# Comhairle Chontae Atha Cliath Theas

## Record of Executive Business and Chief Executive's Order

**Reg. Reference:** SDZ21A/0022      **Application Date:** 02-Dec-2021  
**Submission Type:** New Application      **Registration Date:** 02-Dec-2021

**Proposed Development:** The construction of 569 dwellings, a creche, innovation hub and open space in the Clonburris South West Development Area of the Clonburris SDZ Planning Scheme 2019 as follows: 173 houses comprising 8 two bedroom houses, 153 three bedroom houses and 12 four bedroom houses (147 dwellings in CSW-S4 consisting of 8 two bedroom houses, 127 three bedroom houses & 12 four bedroom houses & 26 three bedroom dwellings in CSW-S3}, all 2 storey comprising semi-detached, terraced, end terrace units (with parking and private open space); (B) 148 duplex apartments/apartments {88 in CSW-S4 & 60 in CSW-S3} comprising 74 two bedroom units and 74 three bedroom units, in 16 three storey buildings. In CSW-S4 Duplex Blocks A,B,C,D,E,F,G,J,K, comprise 8 units (4 two bed & 4 three bed units), Duplex Block H comprises 16 units (8 two bed & 8 three bed units), In CSW-S3 Blocks L, N & O comprise 8 units (4 two bed & 4 three bed units),

Figure 1- Overall Street layout proposed

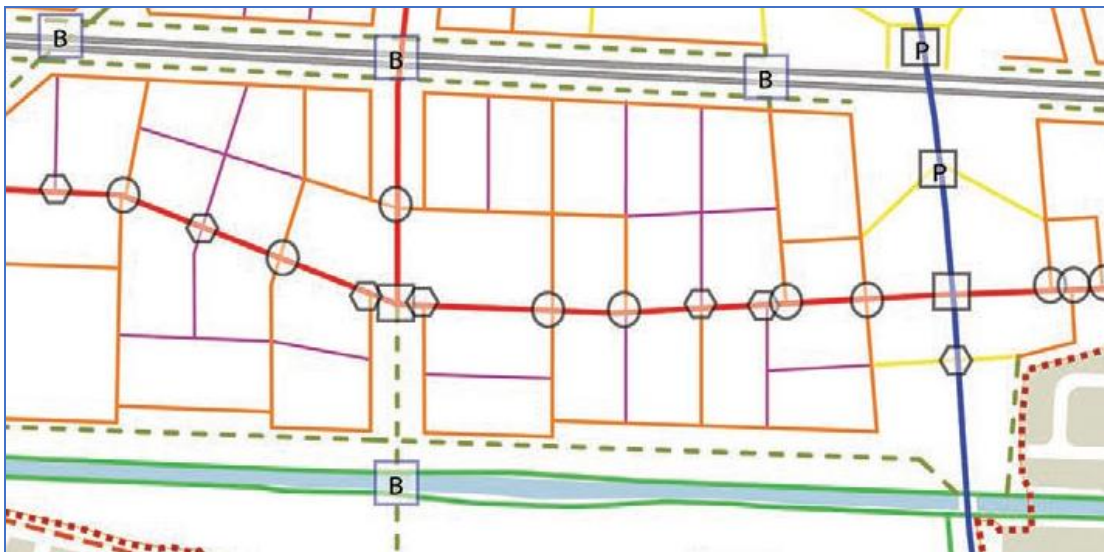
Having regard to the above, it is considered that the movement and street network proposed by the applicant is not consistent with the Planning Scheme in terms of an open permeability network and priority for cyclist and pedestrian movement at the junctions of the link street and local streets.

Figure 3 – Extract of proposed street layout

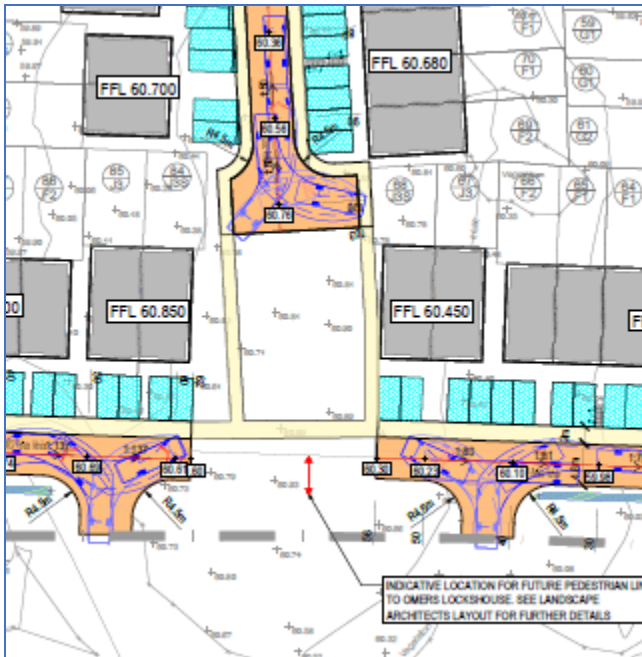
The Roads Section outline that the subject site's internal street layout has been designed with several junctions and a meandering alignment through the development to promote traffic calming. The overall street layout does not match the Planning Scheme. The NTA has recommended removal of access junction to street 3, to promote walking and cycling. The other access and road layout should conform to the Movement Concept. The Roads Section outlines that a three-way junction at

the south of street 3 (shown in Figure 3) should be restored to allow the open flow of traffic around the development in accordance with the transport assessment and strategy that accompanies the Planning Scheme.

Figure 4 road without turning point

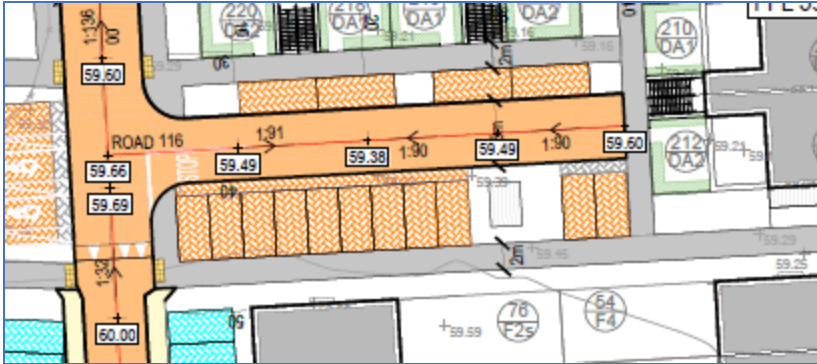
The main internal access roads are designed in accordance with the Design Manual for Urban Roads and Streets (DMURS) and Local Authority taking in charge requirements. The applicant should ensure that turning manoeuvres are achievable on all roads unless short enough to allow reversing as per DMURS (see Figure 4 and Figure 5 below). Consideration should be given to the priority of the road being reversed onto.

Figure 6 link road to future development

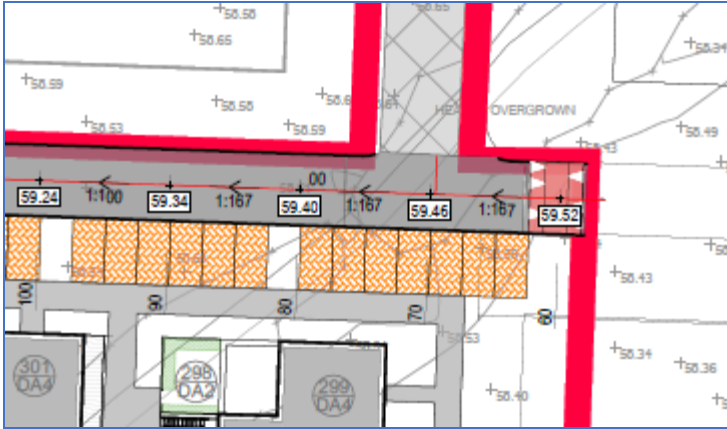
Where links to future developments are left the applicant shall insure that they are built right to the boundary, to ensure continued connections to neighbouring developments (Figure 6).

Figure 8 Refuse turning

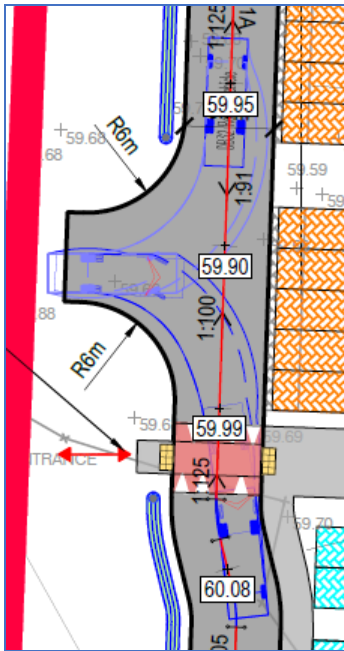
The location and general details of the bin storage areas has been submitted. The autotrack analysis has been submitted detailing refuse vehicle movements around the development.

A overall layout highlighting the refuse collection strategy for the apartment blocks and duplex areas is required.
